# VoltNode

**Title: VoltNode – SA818 EchoLink Node**

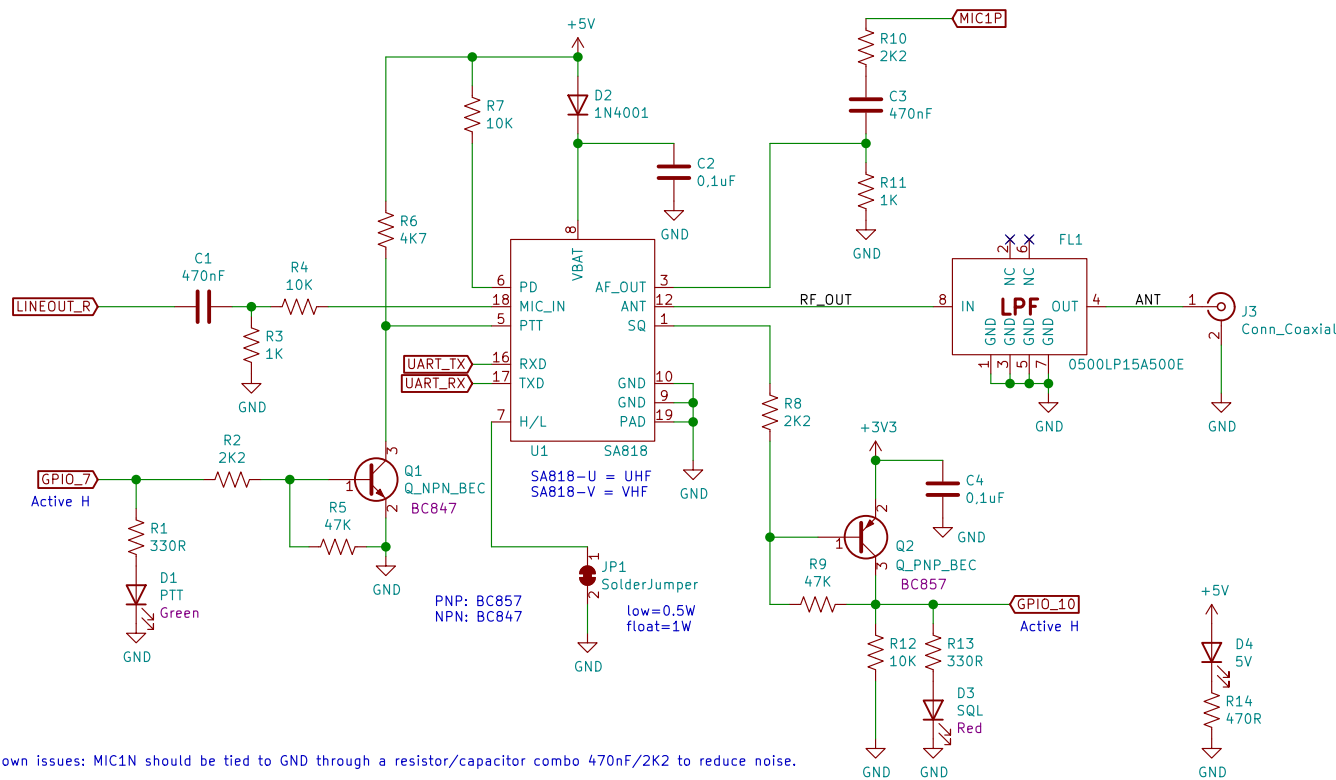
Known issues: MIC1N should be tied to GND through a resistor/capacitor combo 470nF/2K2 to reduce noise.
